The Colong Foundation for Wilderness submission to the Department of Planning, Industry and Environment regarding the Warragamba Dam Raising Project (SSI-8441)

Our Foundation is opposed to the Project, and believes that it cannot properly be approved by the Minister for Planning. We detail the reasons for our Foundation's opposition in this submission. We have divided our submission into 15 sections that deal with different aspects of the Warragamba Dam Raising Project and the Environmental Impacts Statement (EIS) that is currently on exhibition.

Figure 1 - Cross section of proposed dam raise through the central spillway works⁵

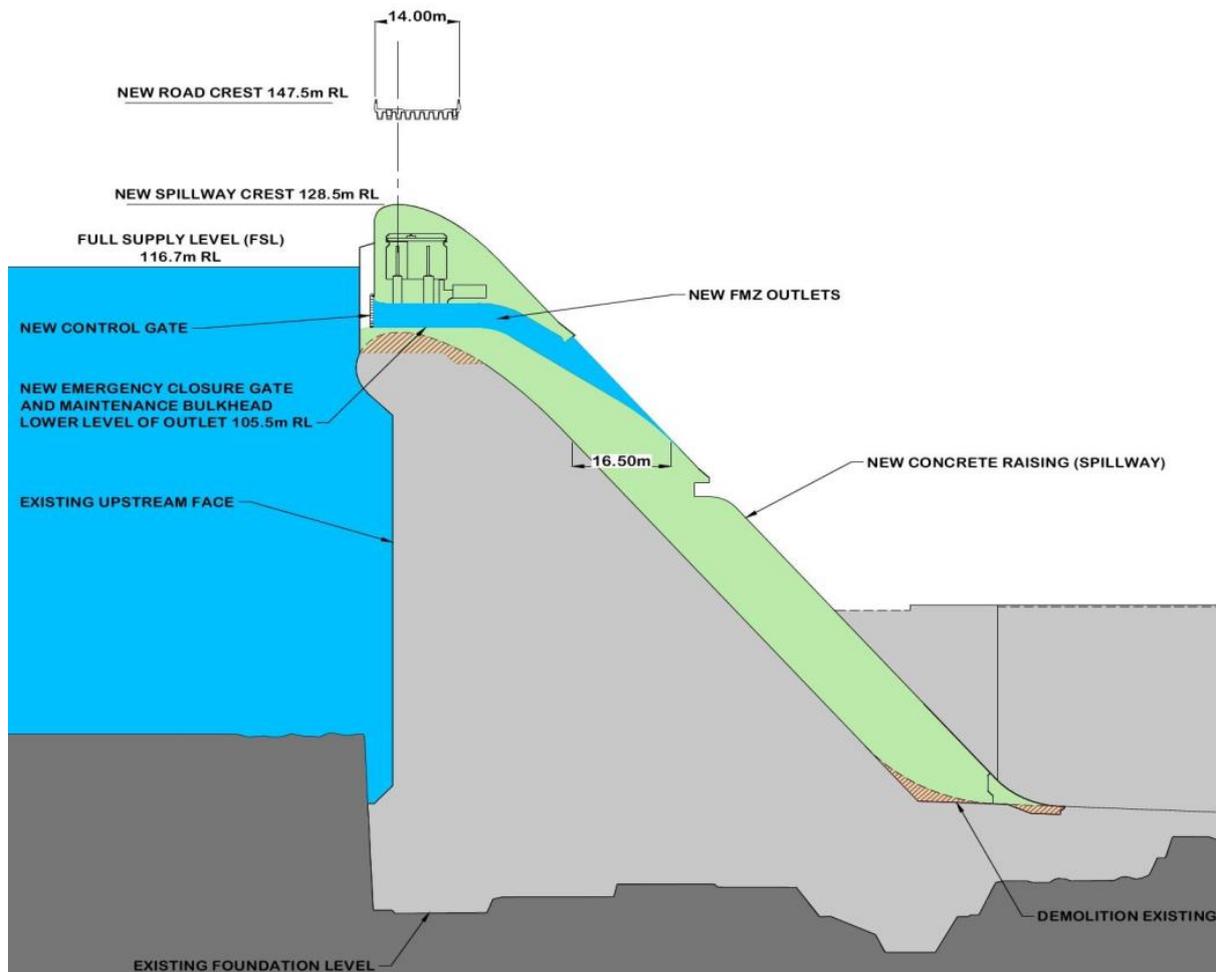
The proposed project will raise the spillway crest level by approximately 12 metres, to 128.5m AHD (see Figure 1). This will be achieved by raising and thickening the main concrete structure of the dam. The additional 12 metres of height creates about 1,000 gigalitres of airspace in the dam that would be used to store floodwaters. The maximum area of the upstream lake will increase by 5,600 hectares to 13,300 hectares. The project includes construction of new Flood Mitigation Zone outlets which will be used to discharge floodwaters. The maximum discharge from the outlets will be 230 gigalitres per day.⁴ Figure 1 shows a cross section of the proposed dam raise through the central spillway.
